**Response to Request for Information
Weigall Sports Complex (SSD-10421)**

I write in response to the Independent Planning Commission's (the Commission) request for information, dated 18 October 2021, in relation to Weigall Sports Complex (SSD-10421).

PROJECT: Sydney Grammar School (SGS) Weigall Sports Complex
RE: SDRP SESSION 60 – 12.08.2020 (first review)

1. SSD10421 – Proposed Weigall Sports Complex, Sydney Grammar School – Request for Additional information

Figure 1: Location of unit 1 and unit 4 within the apartments at 8 Vialoux Avenue relative to the location of Building 1

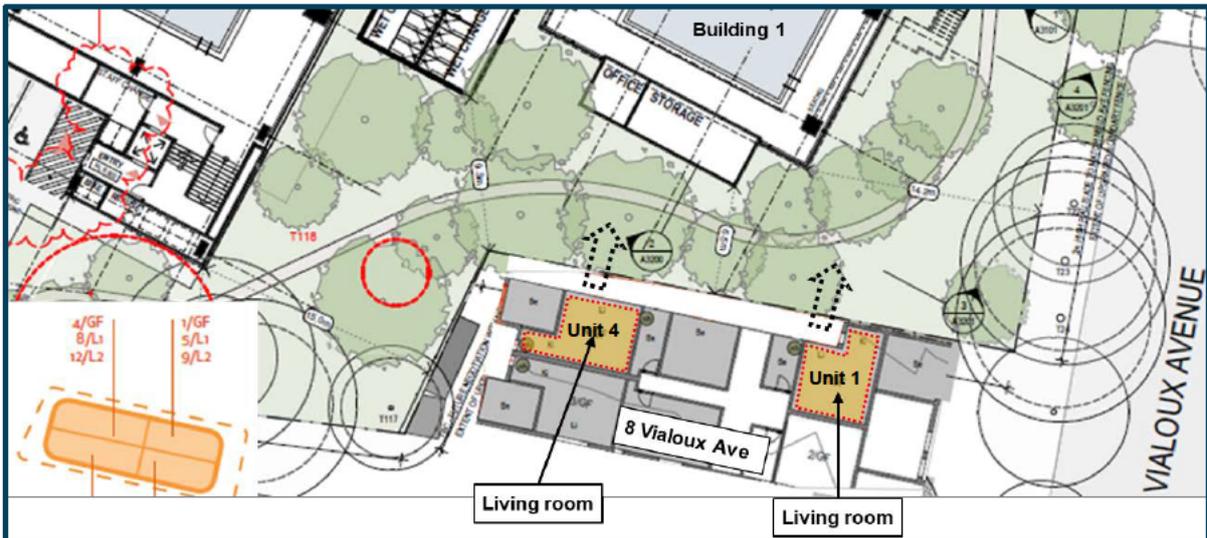
1. Visual impact – Would the proposed design amendments to Building 1 increase the sky views for residential units at 8 Vialoux Avenue, including as an example – Unit 1? What would be the quantitative difference and how has that been assessed?

Noting the above physical attributes, the Department considered the proposed increased reduction of the height of the rear elevation by 4 metres (m) at first floor level and 3m at second floor level would provide a meaningful reduction in bulk/scale in front of the north facing living room windows of 8 Vialoux Avenue. Furthermore, this benefit is magnified due to the skewed orientation of Building 1 to the common boundary.

Notwithstanding, the Department considers that the amendment to the rear setbacks of Building 1 would result in someone within the ground floor level living rooms of the north facing apartments, in a standing position, being afforded approximately 45-degree angle (as a minimum) line of sight of the sky. Given this, the Department is satisfied that the additional setbacks to the upper level of Building 1, coupled with the key physical attributes (building orientation and view corridor) of Building 1, would achieve the desired outcome of providing a variety of sky views for all impacted living rooms including unit 1.

This is further clarified in the **Figure 1** below.

Figure 2: Figure 47 of Department’s Assessment Report showing construction vehicle routes

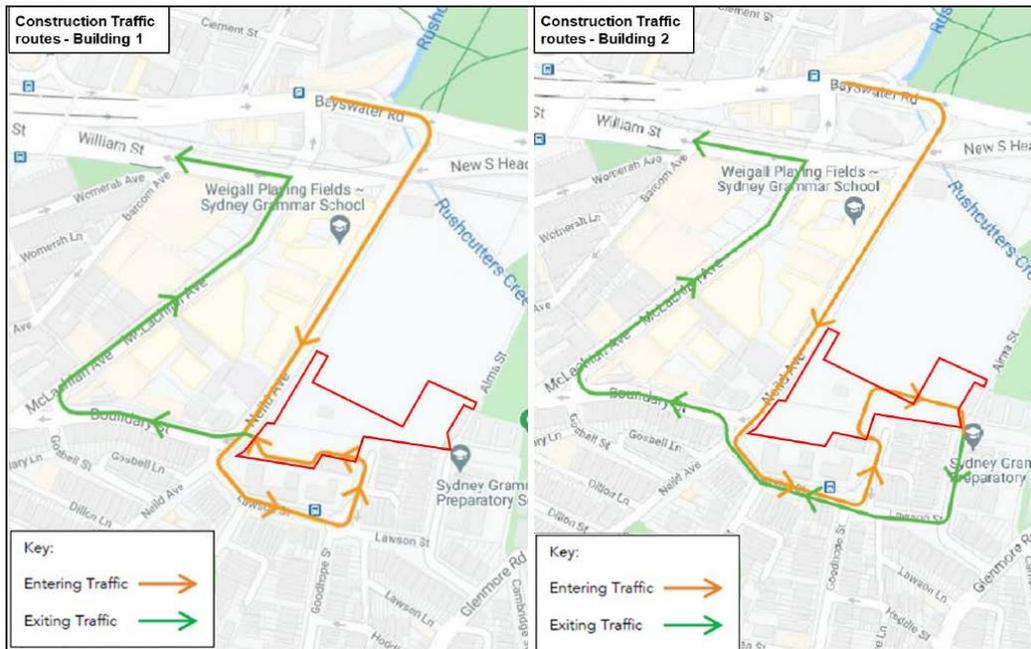
6. Traffic – Could the Department please expand upon the opportunities for alternative arrangements for truck movements in and around the site to minimise construction traffic impacts. In particular, would it be feasible to limit construction traffic to Neild Avenue and avoid local residential streets?

The Department’s assessment shows (at **Figure 47** in page 88) that construction traffic would arrive from Neild Avenue and depart along Boundary Road.

The Department considers condition C15 could be updated to require the Applicant to investigate alternative construction vehicle entry/exit arrangements to exclude movements along Lawson Street, Vialoux Avenue and Alma Street.

This is further clarified in **Figure 2** below.

Figure 9 - Lawson Street / Vialoux Street Intersection and the Physical Constraints

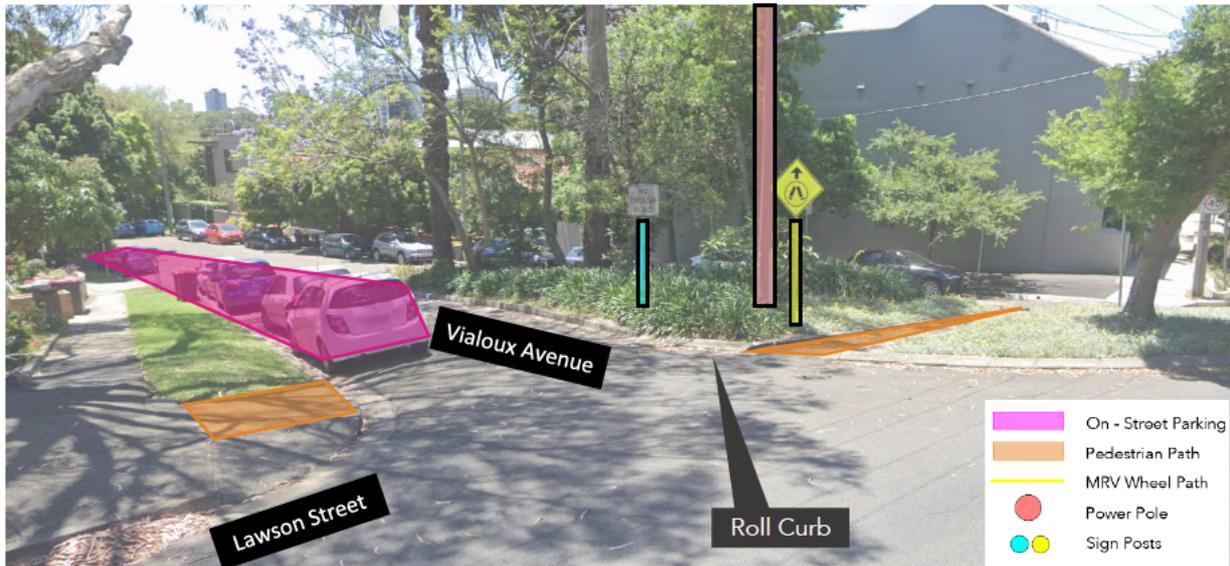
- a) Provide further details to demonstrate that medium rigid vehicles (as specified in the EIS) and other construction trucks will be able to manoeuvre from Lawson Street into Vialoux Street without conflict with parked cars or the existing central island with the overhanging trees. If suitable truck access is not achievable, suggest an alternative construction truck entry point for the site.

The Woollahra Council's *Attachment 1 - Site Waste Minimisation and Management* specifies the length and width of the domestic waste collection truck as 8 meters and 2.5 meters respectively (see Figure 8). According to the AS2890.2:2018, an MRV can be up to 8.8 meters long and 2.5 meters wide. It is acknowledged that an MRV can be longer than the domestic waste collection truck used by Council. Therefore, a swept path analysis has been undertaken to confirm that an MRV can manoeuvre from Lawson Street into Vialoux Avenue. Consideration has been made to kerbs, power poles, sign posts and on-street parking spaces on Lawson Street and Vialoux Avenue, see Figure 9.

It has been found that an MRV is able to manoeuvre within the physical constraints of the carriageways and not obstruct any on-street parking, as shown in Figure 10. The body of the MRV overhangs slightly over the median island on Vialoux Avenue; however, there is sufficient clearance between the vehicle and the sign posts / power pole.

It is noted that the corner where the HRV has been shown to overhang the median island there is a roll curb allowing vehicles to mount it, if required.

Drawing Title
BUILDING 01
SPORTS FACILITIES BUILDING
GENERAL ARRANGEMENT PLAN
GROUND

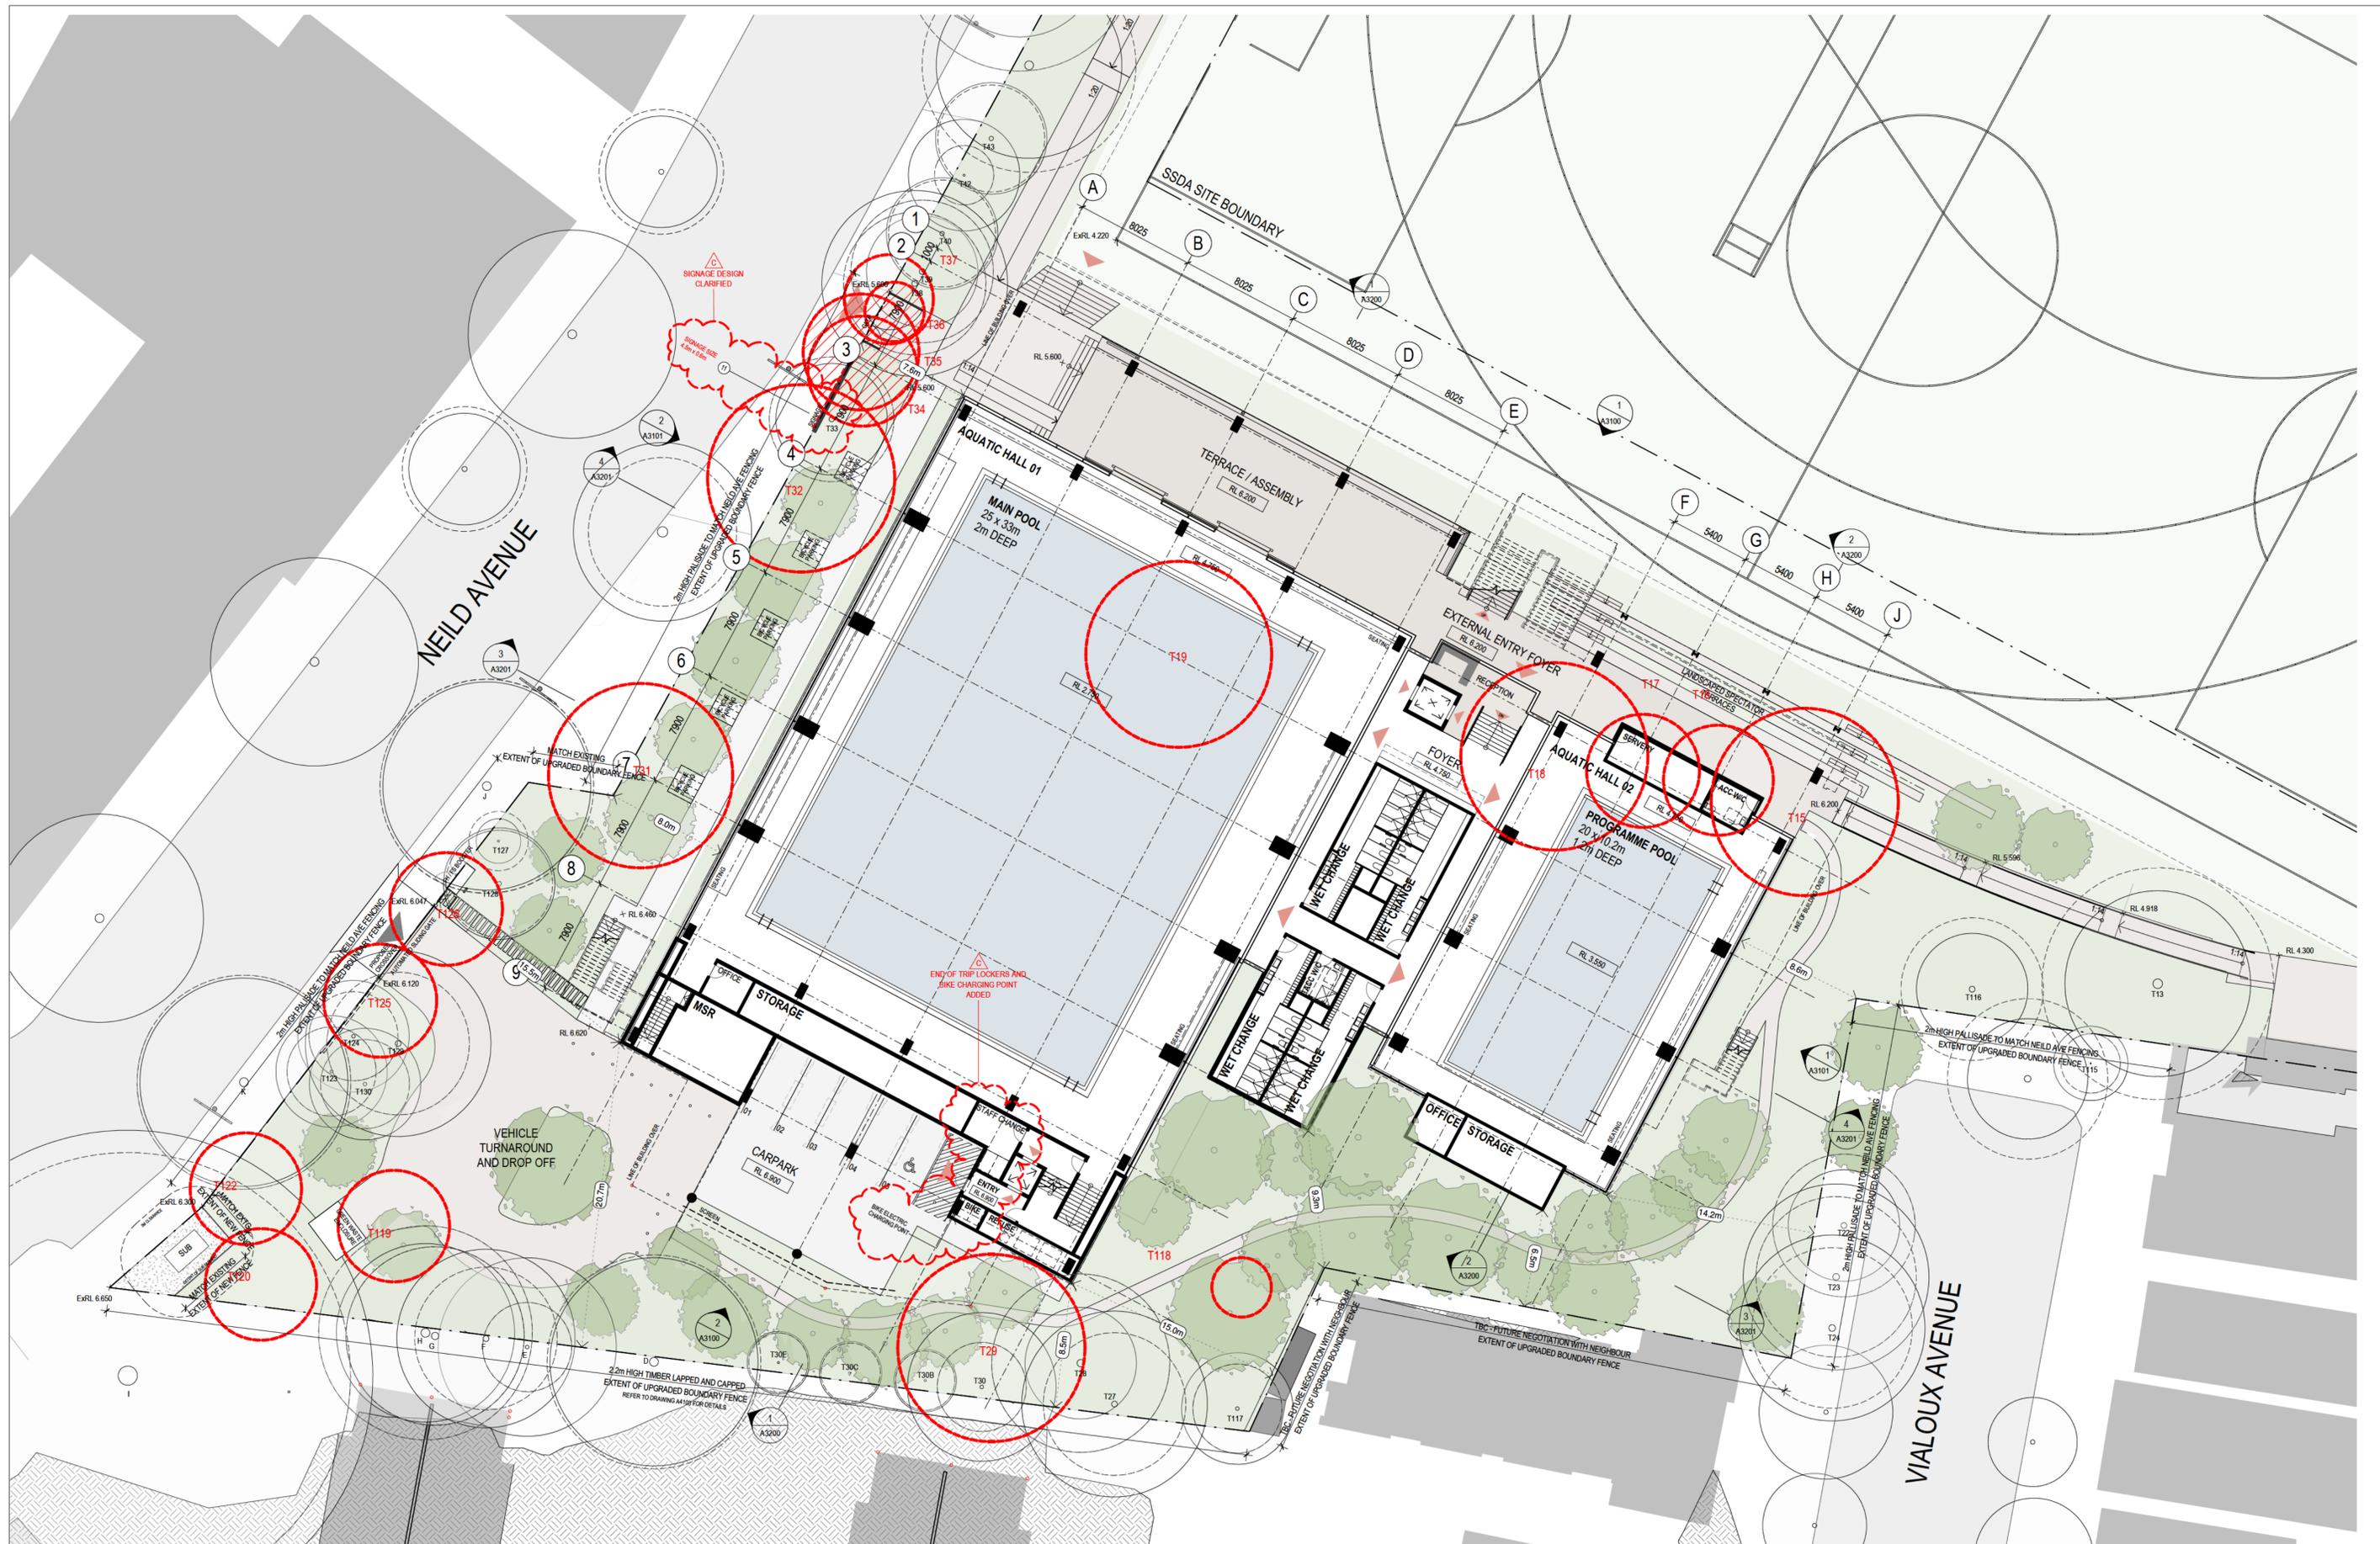
Confirm what end of trip facilities will be made available to cyclists, with reference to the requirements of the Woollahra Development Control Plan 2015.

The proposal involves the provision for two (2) all-day bicycle parking spaces for staff. While not stored individually, the two spaces are proposed to be located in one securely locked room. This is in accordance with the Planning Guidelines for Walking and Cycling and is considered sufficient for this development.

The proposal involves the provision of two (2) bicycle parking spaces for staff. Therefore, one (1) shower and one (1) change cubicle has been provided within the staff change rooms in line with the DCP requirements.

The proposal involves the provision of two (2) bicycle parking spaces for staff. Therefore, the proposal involves the provision of one (1) charging point within the staff bicycle storage area to accommodate potential electric bicycle users.
